# ADDENDUM No. 1

## ITB No. 4524

### 2018 Water Main and Sanitary Sewer projects

**BASKETBALL HOOP POLE  
FOUNDATION DETAIL**

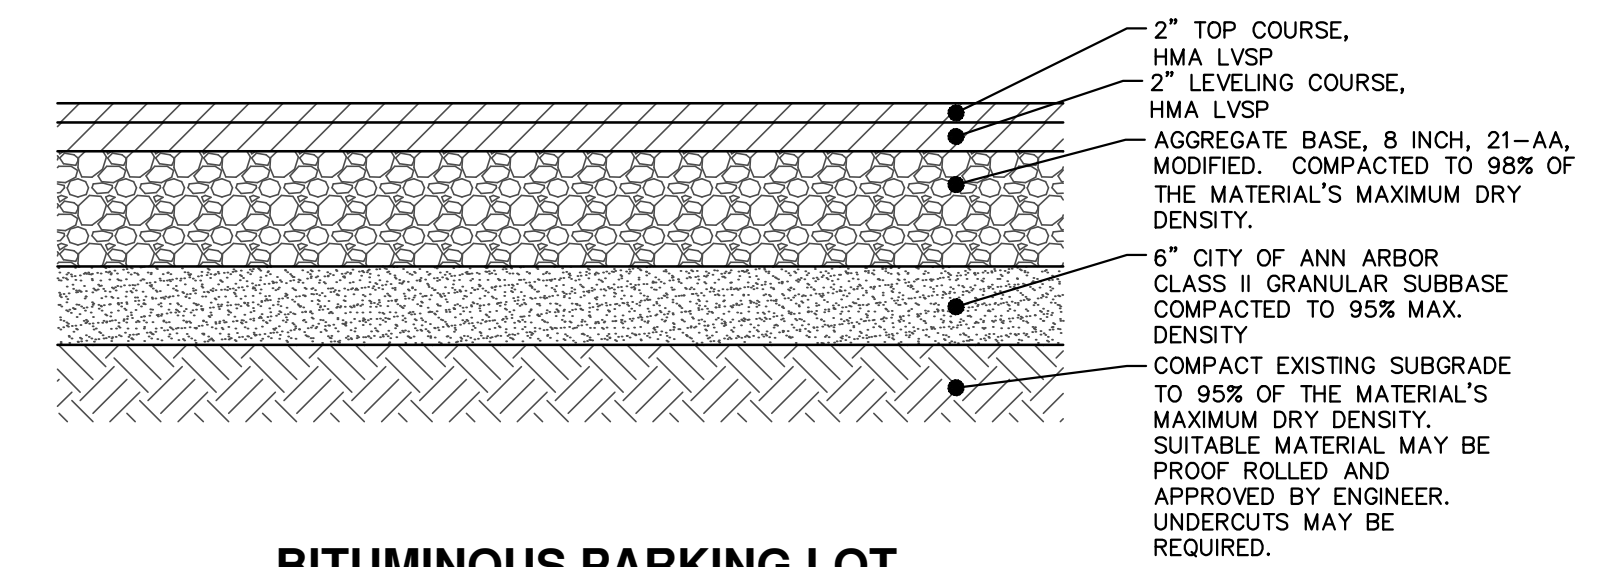
**Question 7:** The plans shows to remove both basketball hoops. The spec book and pay item only calls for one basketball hoop to be removed. Is the intent to remove both basketball hoops or just the one?

**Answer 7:** The westerly pole assembly will need to be removed and replaced as it is within the influence of the sanitary sewer trench. The easterly assembly is to be left in place and protected. The plan notes have been revised accordingly.

SHEET No.  
16 OF 29

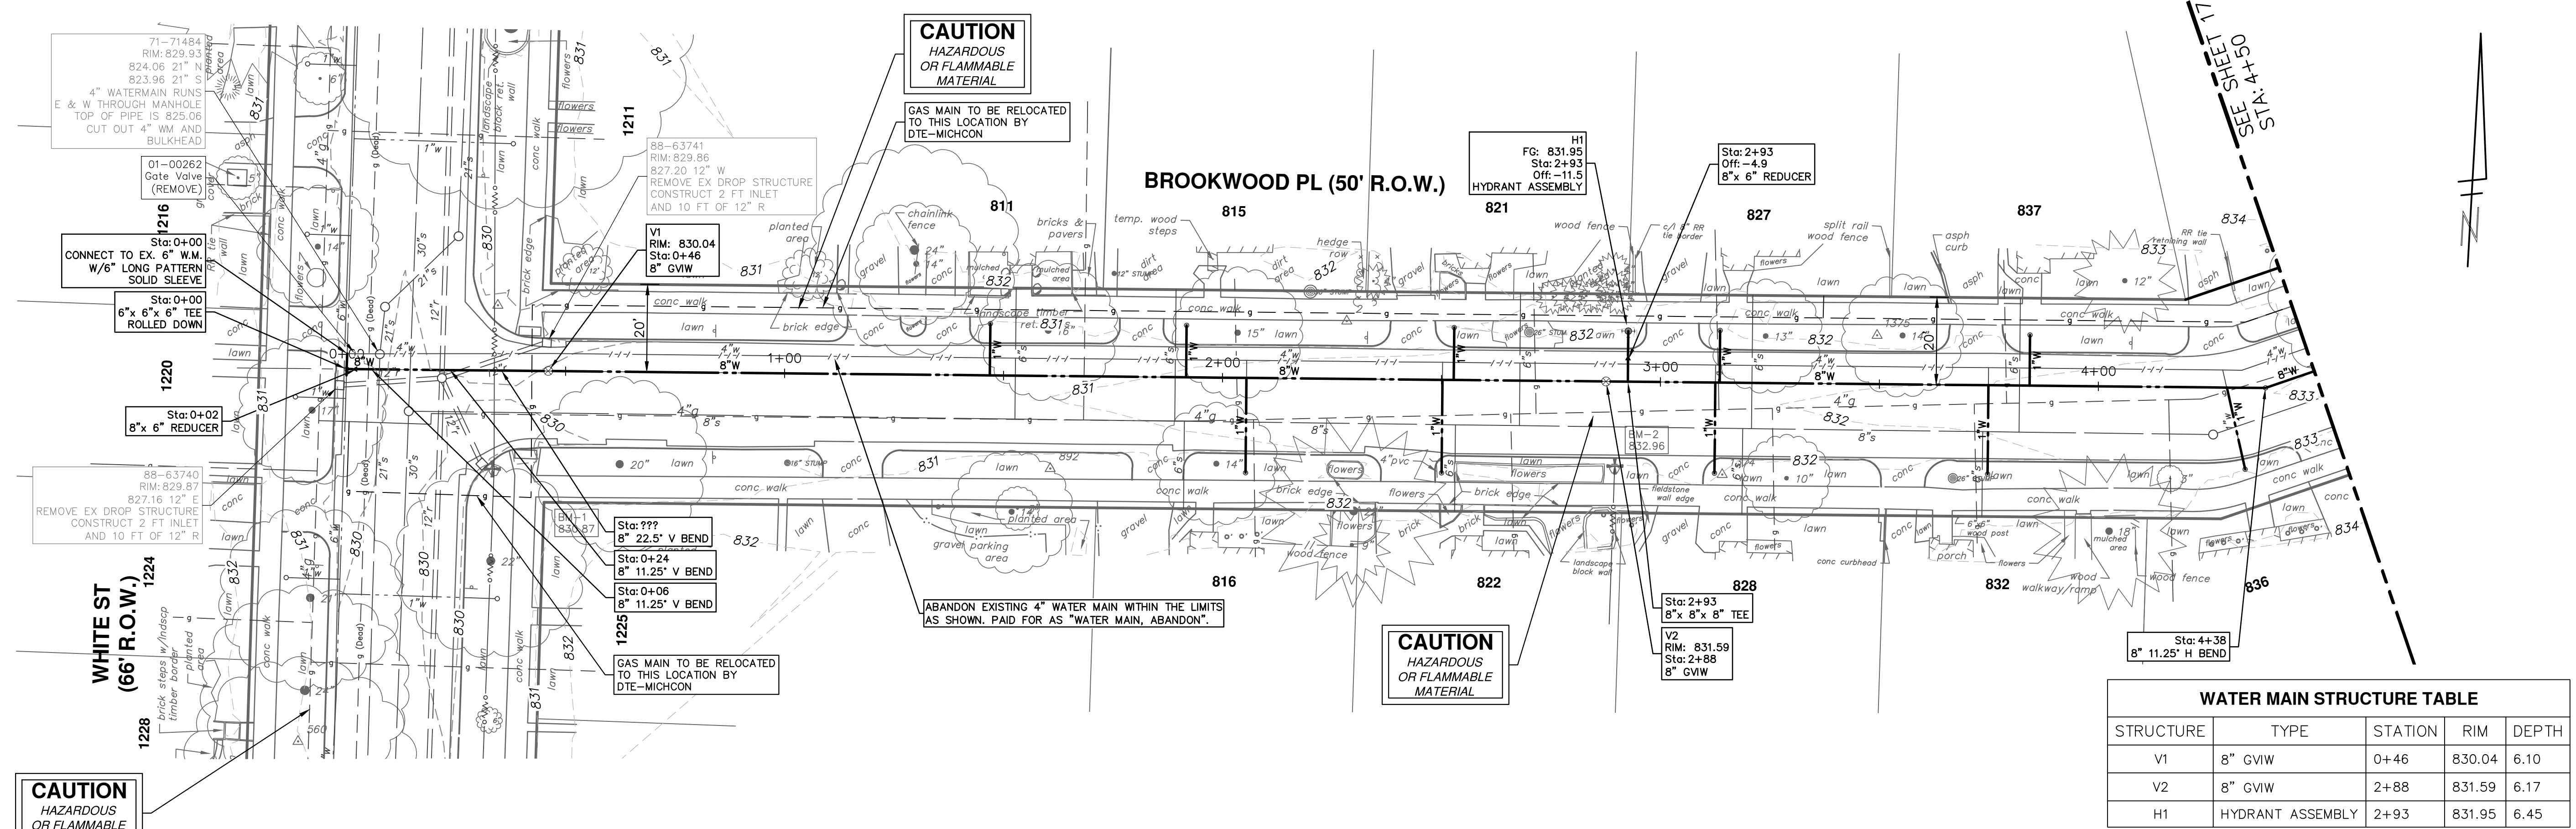
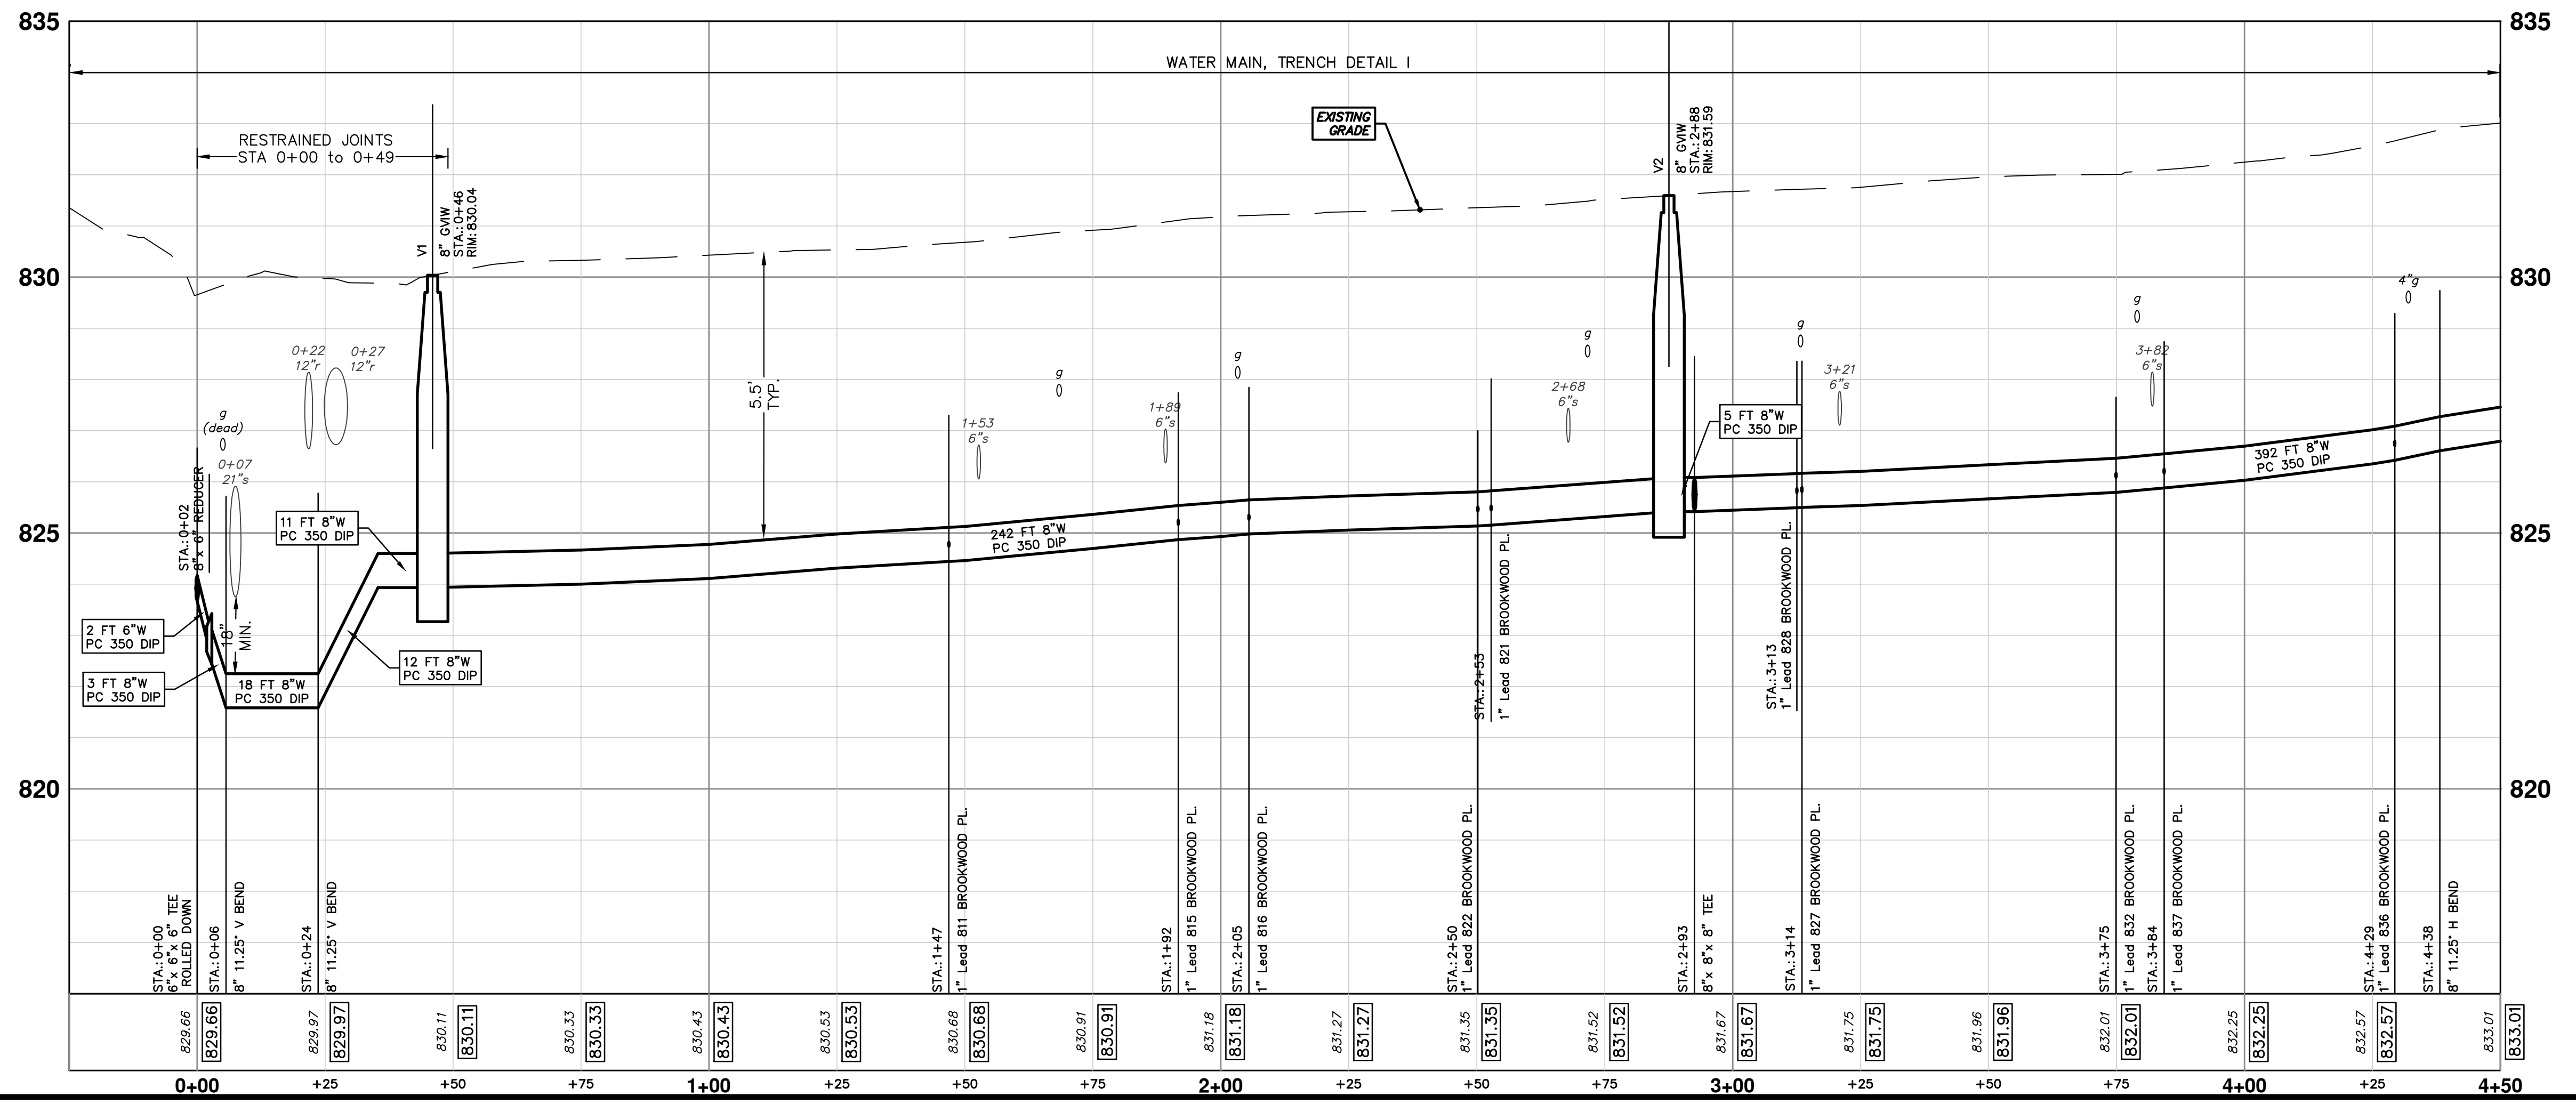
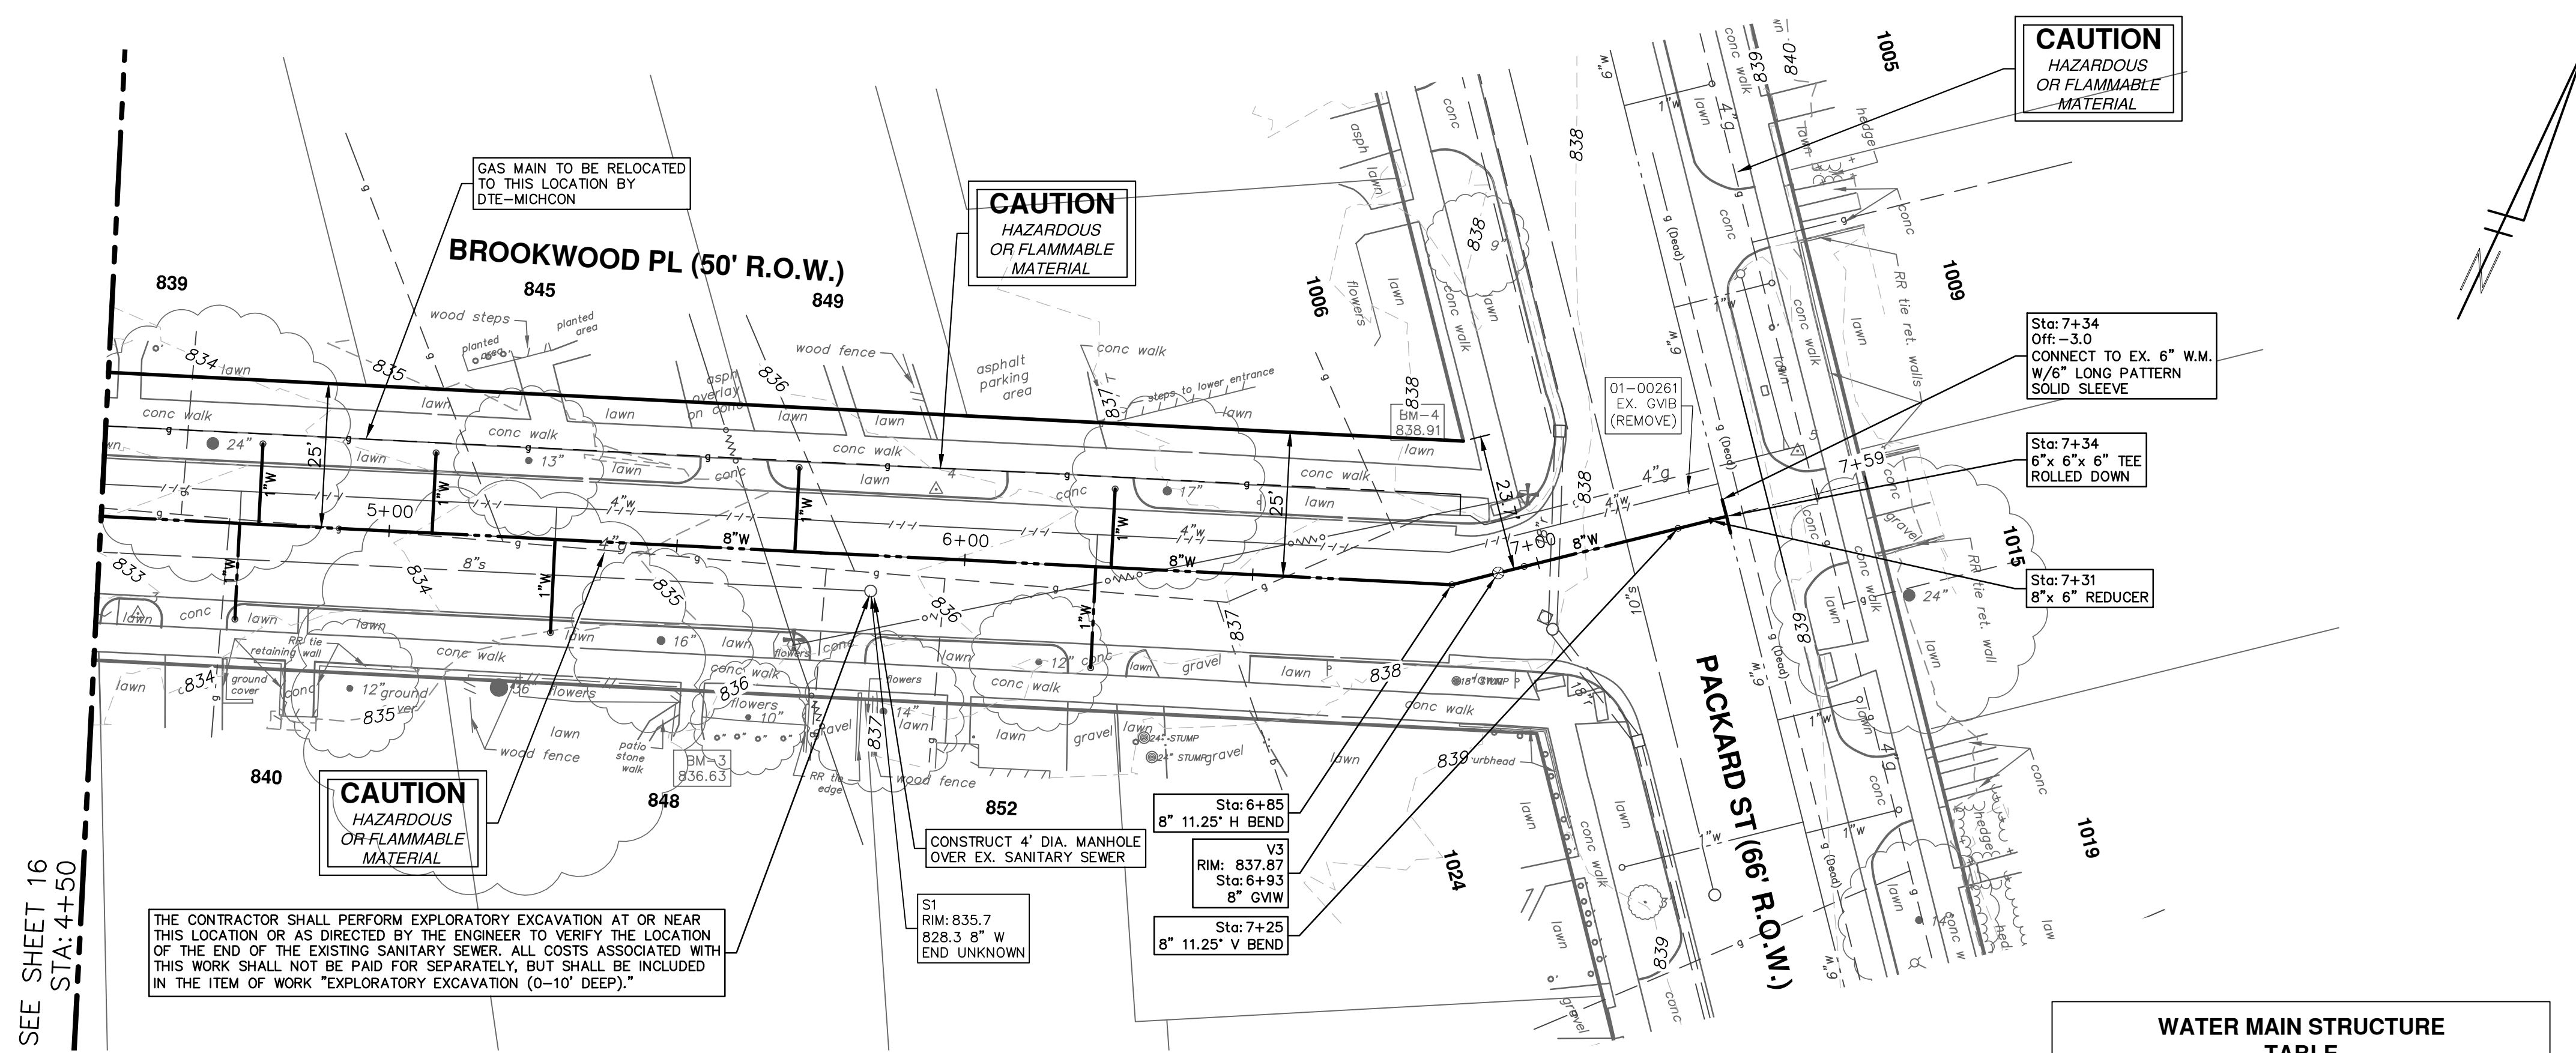
**Question 5:** Are there rim elevations and inverts for the 2' diameter structures that are shown on sheet 16, 24, 29?

**Answer 5:** The information has been added, and is included in the addendum.
